SUBARU®

NUMBER 11-39-91

SERVICE BULLETIN

SUBJECT: LEGACY ENGINE BLOCK MODIFICATION/ A/C COMPRESSOR BRACKET MOUNTING BOLT CHANGE

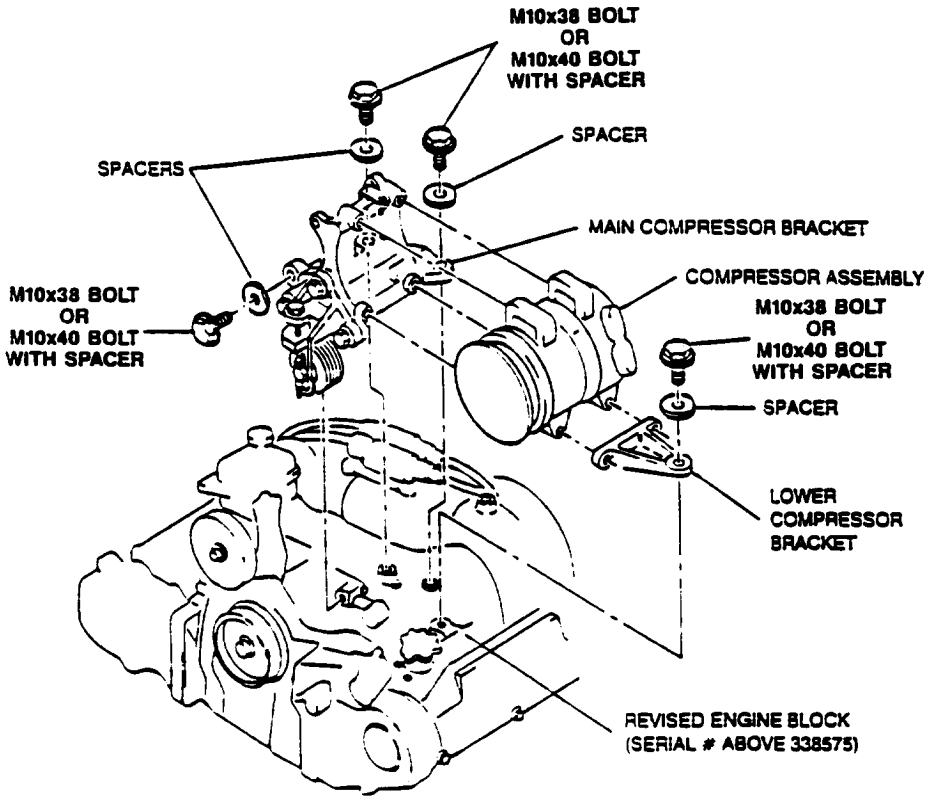
The Legacy engine block has undergone a change which decreased the A/C bracket bolt hole depth by 2mm. Shorter mounting bolts or spacer kits will be required when using A/C Kits P/N G3010AA000 and P/N G3010AA010 on production engines after Engine #338575 and after Engine #765733.

NOTE: When installing a modified engine block in an A/C equipped vehicle, a spacer kit or shorter mounting bolts must be used.

CAUTION: Damage to short block may result if spacer kit or shorter bolts are not used.

Spacer kits will be available separately through normal Parts channels by ordering P/N G3010AA020.

Revised A/C Kits P/N G3010AB000 and P/N G3010AB010 will initially have spacer kits supplied, a running production change will take place shortly thereafter, incorporating the shorter mounting bolts.
